HUSBY SUBDIVISION, RESUBDIVISION OF LOTS

1 AND 2

APPLICATION NUMBER 15 DATE May 1, 2003

APPLICANT Husby Subdivision, Resubdivision of Lots 1 and 2

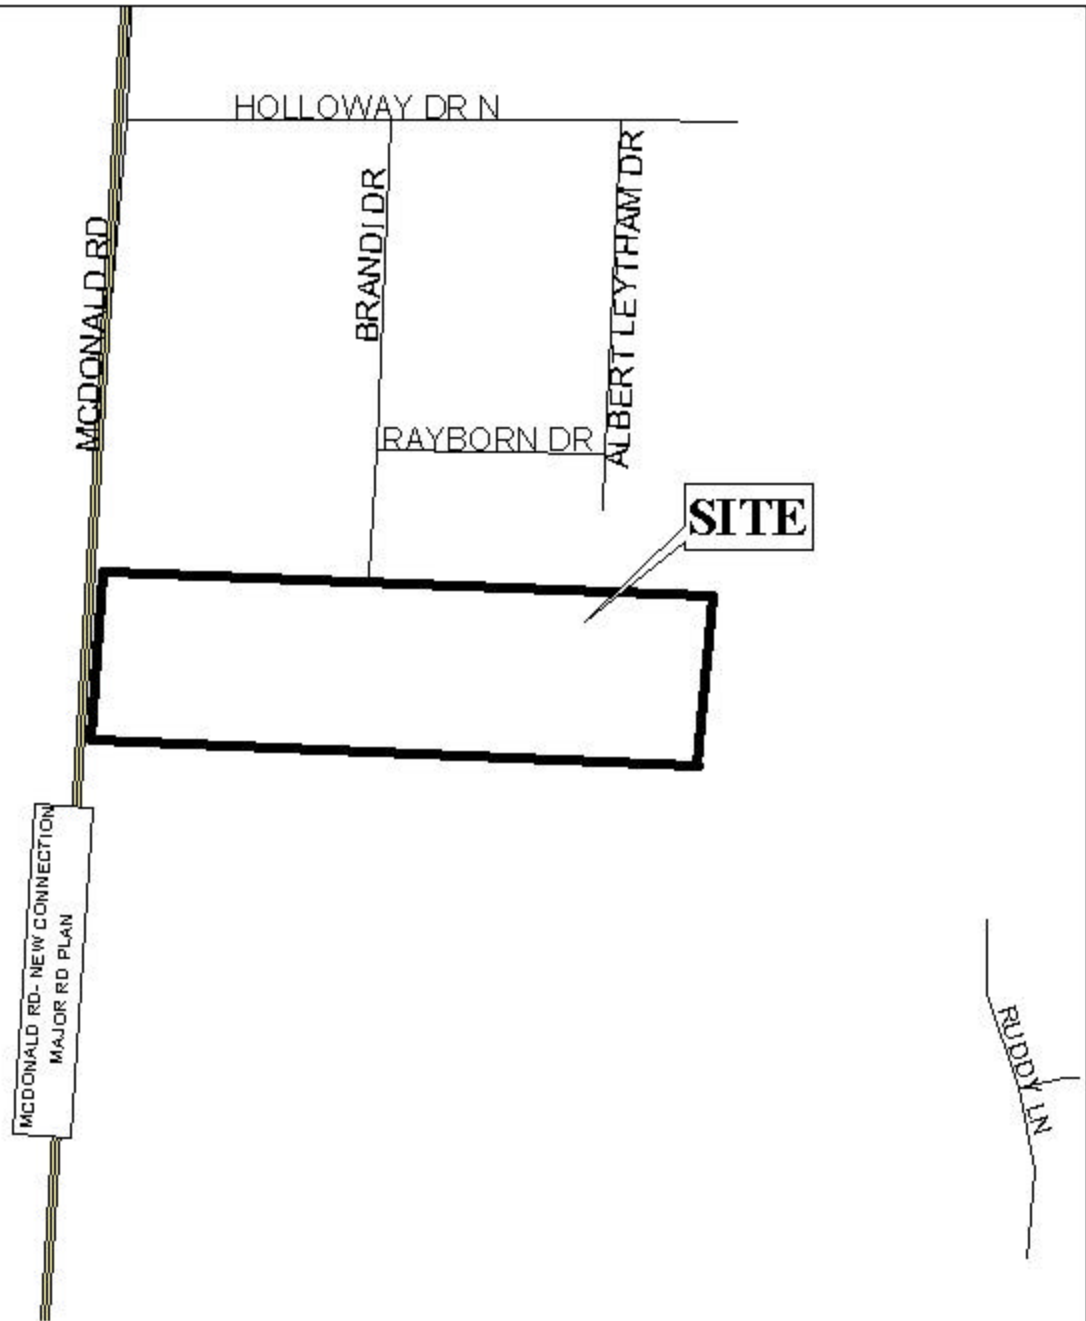
The plat illustrates the proposed 2 lot, 9.6 ± acres subdivision which is located on the East side of McDonald Road, 950' + South of Holloway Drive North. The subdivision is served by public water and individual septic systems.

The site fronts McDonald Road, a planned major street, and the existing right-of-way is shown as 80 feet. The Major Street Plan requires a 100-foot right-of-way, therefore, the provision of a 75-foot setback (which includes the required minimum building setback of 25-feet), from the centerline of McDonald Road, to provide for the right-of-way of the planned major street should be provided. Additionally, as a means of access management, a note should be placed on the final plat stating Lots 1 and 2 are limited to one curb cut each to McDonald Road, with the size, location and design to be approved by County Engineering.

Additionally, Lot 1 exceeds the maximum width to depth ratio as recommended by the Subdivision Regulations, thus a waiver of Section V.D.3. would be needed.

This site is located in the County, thus a note should be placed on the final plat stating that any lots which are developed commercially and adjoin residentially developed property must provide a buffer, in compliance with Section V.A.7. of the Subdivision Regulations.

With modifications and a waiver of Section V.D.3. (width to depth ratio), the plat will meet the minimum requirements of the Subdivision Regulations and is recommended for Tentative Approval subject to the following conditions: 1) the provision of a 75-foot setback (which includes the required minimum building setback of 25-feet), from the centerline of McDonald Road; 2) placement of a note on the final plat stating that Lots 1 and 2 are limited to one curb cut each to McDonald Road with the size, location and design to be approved County Engineering; and 3) the placement of a note on the final plat stating that any property that is developed commercially and adjoins residentially developed property shall provide a buffer, in compliance with Section V.A.7. of the Subdivision Regulations
